AMENDED REGIONAL INTERESTS DEVELOPMENT APPROVAL (RIDA) 11 September 2018 25 June 2019

RPI18/014 – Lynd Resources Pty Ltd (ACN 610 450 498) C/- Ardent Group Pty Ltd (ACN 604 696 764) - Tupiza Project.

(Given under section 5156 of the Regional Planning Interests Act 2014)

Figure 3

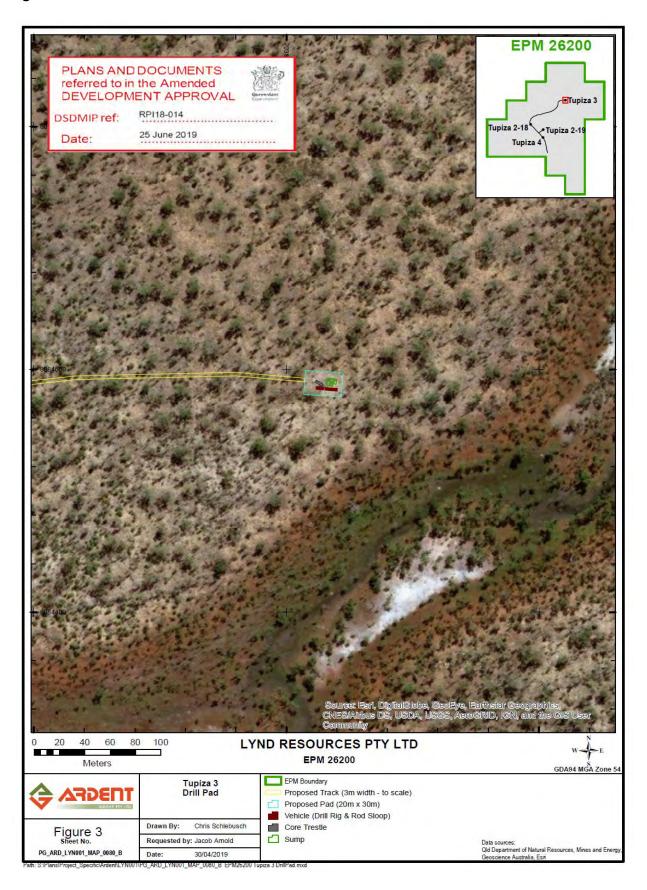
Condition number	Condition	Timing for condition
1.	Carry out the approved activities and disturbance of land generally in accordance with: a) The activities identified in Table 1: Approved activities. b) The activities defined in Table 2: Definitions of Activities. c) The locations provided in Table 3: Tupiza resource activities and associated locations. d) The approved plans: • Figure 1: Location of Proposed Exploration Activities within the Gulf Rivers SEA, Sheet No. PG_ARD_LYN001_MAP_0048_B, dated 30/04/19, submitted with the applicant's request for an amended RIDA on 22 May 2019 (refer Attachment 1) Sheet No. ADMG_ARD _LYN001_MAP_0048_A, dated 30/04/18, provided by the applicant and lodged with the application on 30 May 2018 (refer Attachment 1); • Figure 1: Footprint of the Tupiza 1 drill pad (non-target drill pad), Sheet No. ADMG_ARD_LYN001_MAP_0078_A, dated 2/07/18, submitted with the applicant's response to the Requirement Notice on 13 July 2018 (refer Attachment 1); • Figure 2: Footprint of the Tupiza 2-18 drill pad, Sheet No. PG_ARD_LYN001_MAP_0079_B, dated 30/04/19, submitted with the applicant's request for an amended RIDA on 22 May 2019 (refer Attachment 1) Sheet No. ADMG_ARD_LYN001_MAP_0079_A, dated 2/07/18, submitted with the applicant's response to the Requirement Notice on 13 July 2018 (refer Attachment 1); • Figure 3: Footprint of the Tupiza 3 drill pad	At all times.

(non-target drill pad), Sheet No.

PG_ARD_LYN001_ MAP_0080_B, dated
30/04/19, submitted with the applicant's
request for an amended RIDA on 22 May
2019 (refer Attachment 1) Sheet No.

ADMG_ARD_LYN001_MAP_0080_A,
dated 2/07/18, submitted with the
applicant's response to the Requirement
Notice on 13 July 2018 (refer Attachment
1);

Figure 4

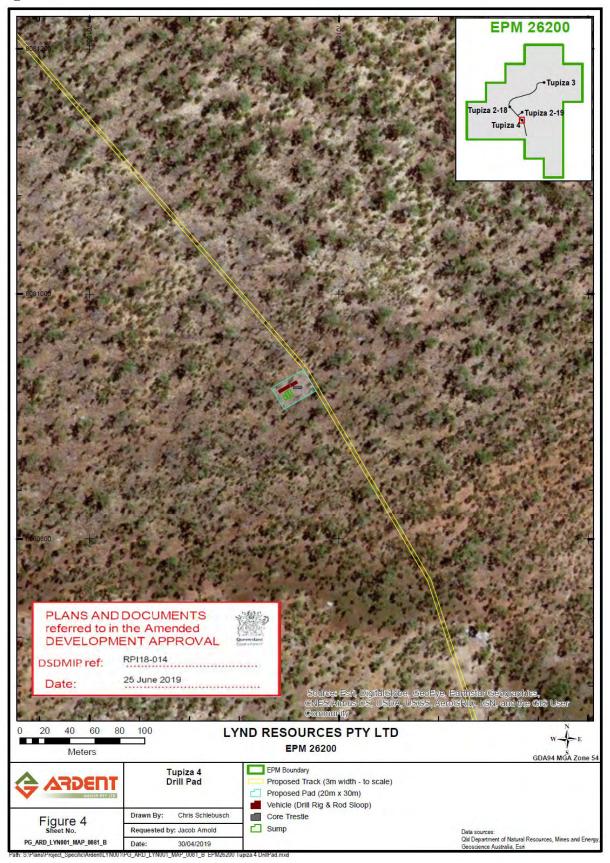
- Figure 4: Footprint of the Tupiza 4 drill pad,
 Sheet No. PG_
 ARD_LYN001_MAP_0081_B, dated
 30/04/19, submitted with the applicant's
 request for an amended RIDA on 22 May
 2019 (refer Attachment 1) Sheet No.
 ADMG_ARD_LYN001_MAP_0081_A, dated
 2/07/18, submitted with the applicant's

Figure 5

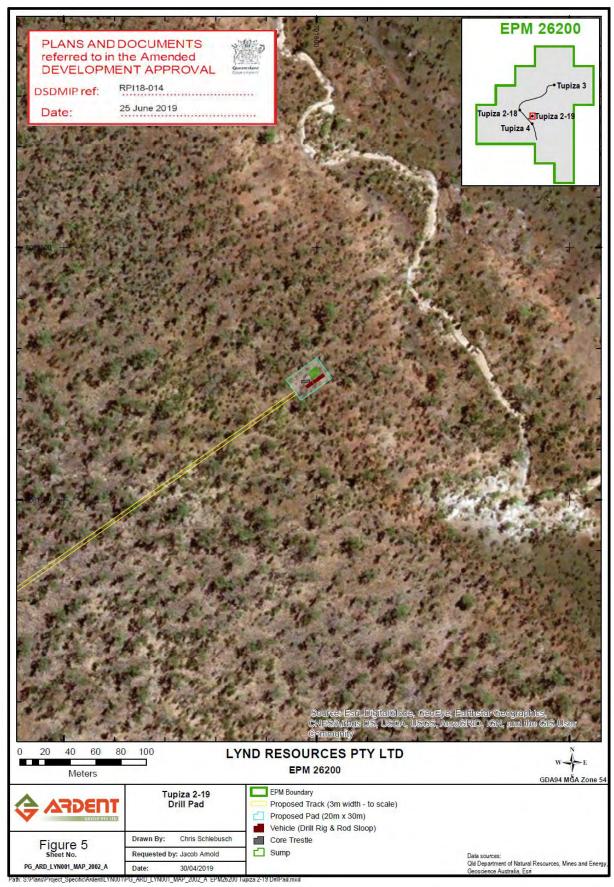
response to the Requirement Notice on 13
 July 2018 (refer Attachment 1);
- ◆ Figure 5: Footprint of the Tupiza 2-19 drill pad, Sheet No. PG_ARD_LYN001_ MAP_2002_A, dated 30/04/2019, submitted with the applicant's request for an amended RIDA on 22 May 2019 (refer Attachment 1) campsite and laydown area, Sheet No. ADMG_ARD_LYN001_ MAP_0072_A, dated 28/06/18, submitted with the applicant's response to the Requirement Notice on 13 July 2018 (refer Attachment 1);

Figure 10

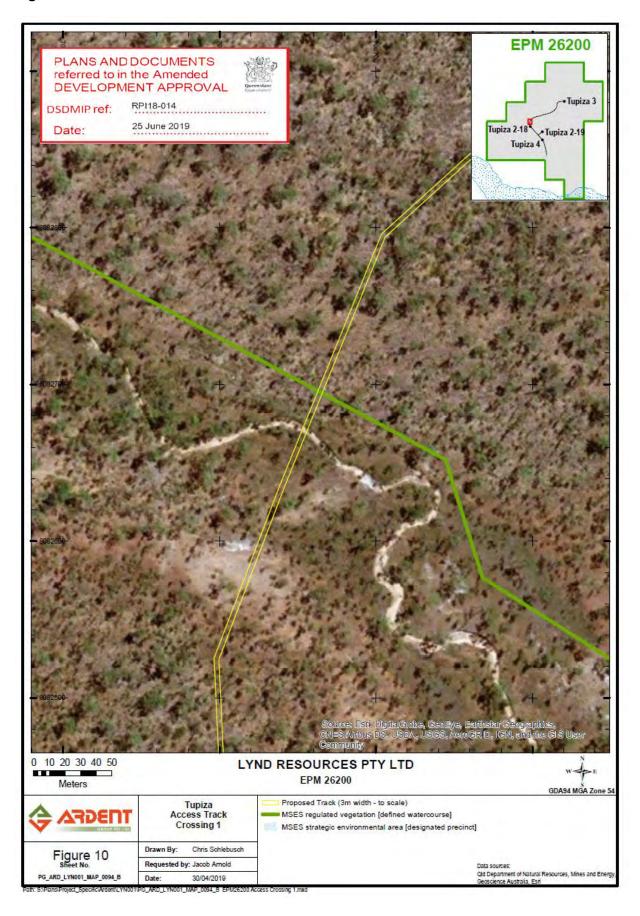
- Figure 710: Tupiza Access Track
 Crossing 1, Sheet No.
 PG_ARD_LYN001_ MAP_0094_B, dated
 30/04/2019, submitted with the
 applicant's request for an amended
 RIDA on 22 May 2019 (refer Attachment

1) access track regulated vegetation
 crossing 1, Sheet No. ADMG_ARD
 _LYN001_MAP_0094_A, dated 3/07/18,
 submitted with the applicant's response to
 the Requirement Notice on 13 July 2018
 (refer Attachment 1));

Figure 11

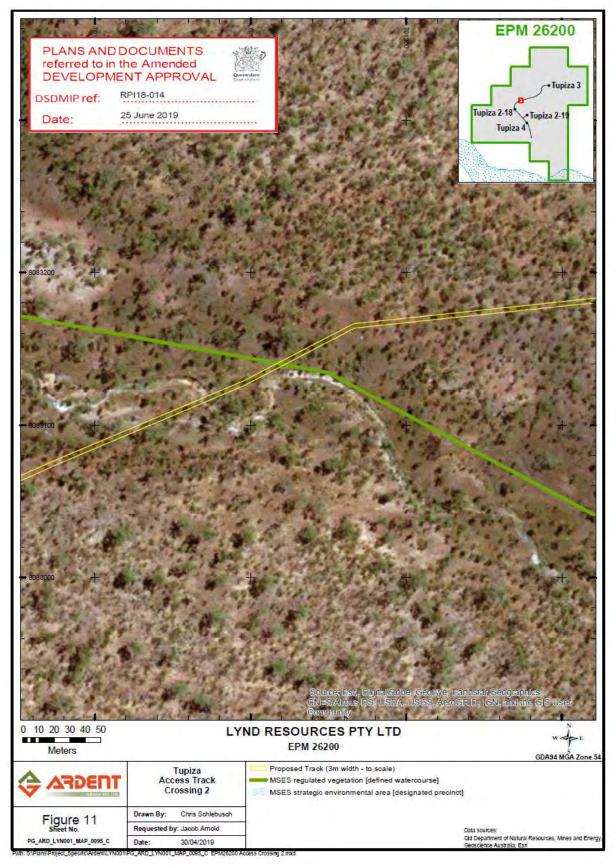
- Figure & 11: Tupiza Access Track

Crossing 2, Sheet No. PG_ARD_LYN001_ MAP_0095_C, dated 30/04/2019, submitted with the applicant's request for an amended RIDA on 22 May 2019 (refer Attachment 1) access track regulated vegetation crossing 2, Sheet No. ADMG_ARD _LYN001_MAP_0095_B, dated 3/07/18, submitted with the applicant's response to the Requirement Notice on 13 July 2018 (refer Attachment 1); • Figure 9 12: Schematic of proposed drill pad, undated, provided by the applicant and lodged with the application on 30 May 2018 (refer Attachment 1); • Figure 10 13: Schematic of fuel storage and Laydown Area, undated, provided by the applicant and lodged with the	
	 application on 30 May 2018 (refer Attachment 1); Figure 11 14: Schematic of Temporary Mobile Campsite, undated, provided by the applicant and lodged with the application on 30 May 2018 (refer Attachment 1).

Figure 13: Schematic of fuel and laydown area

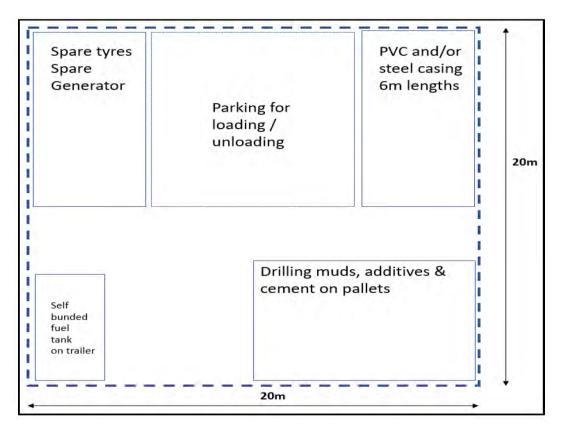
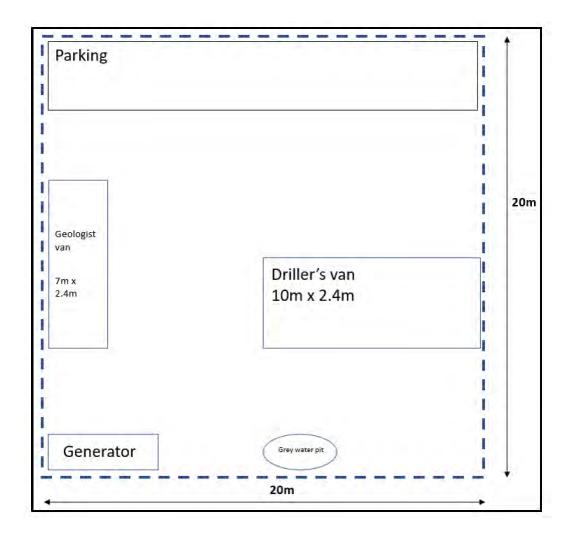
Area of regional	Location	Resource activity	Area of disturbance
interest			(hectares)
Gulf Rivers Strategic	Part Lot 4	Access Tracks	3.08 2.5
Environmental Area	on SE1	Drill pad (four in total, each being	0.24
		20m x 30m)	
		Temporary Fuel Storage and	0.04 0.0 *
		Laydown Area (20m x 20m)	
		Temporary Mobile Campsite (20m	0.04 0.0 *
		x 20m)	
		Total area of disturbance is 3.40 2.74ha.

^{*}As the resource activity will now be located within a drill pad, separate disturbance area is no longer required. There will be no additional disturbance, as disturbance is accounted for within drill pad disturbance.
